ID	I support the Heathcote Expressway (Preferred Route)	I generally support the Heathcote Expressway but have some concerns	I do not support the Heathcote Expressway	Full Comments Heathcote Expressway consultation submissions
1	Y			This would be such a fantastic thing to have. A great incentive for people to use environmentally friendly transport and the added health benefits too. This will be a huge incentive to many in Heathcote to get on a bike!
2	Y			Excellent idea and plans. As a cyclist I would not allow any children or even teenagers to cycle under the motorway and through Port Hills Road due to excessive trucks and danger. I love the plans - thanks.
3	Y			No comment
4	Y			We have been waiting for this for a long time!
5	Y			I think the plans for this cycleway look great. Provides me with a great link to the new St Asaph Street cycleway. I will be more likely to bike to work when these are all completed - it makes the journey safer and more enjoyable.

Heathcote Expressway — Puari i Kahukura

SUBMISSION ON PROPOSED HEATHCOTE CYCLEWAY ROUTE IN MACKENZIE AVE

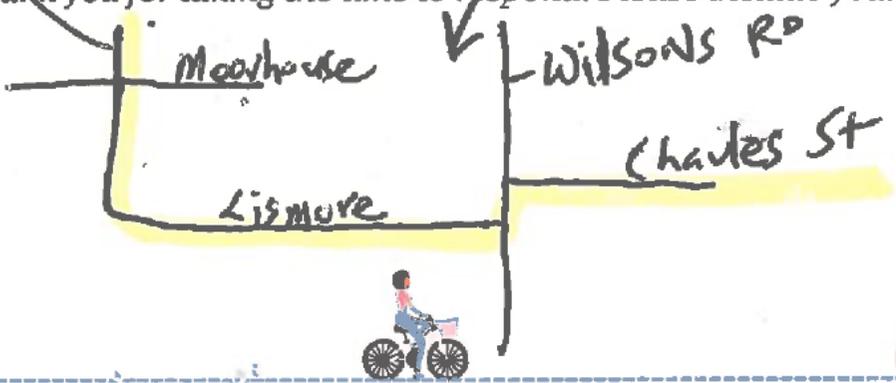
Much less public ~~service~~ drive/in and out all day to premises

Quieter and less traffic

Rail corridor (Lismore) could easily have better lighting

Much Safer for cyclists

Low Business Impact. Cycling time difference ^{just} 30 sec

FAR FAR SUPERIOR CYCLE ROUTE
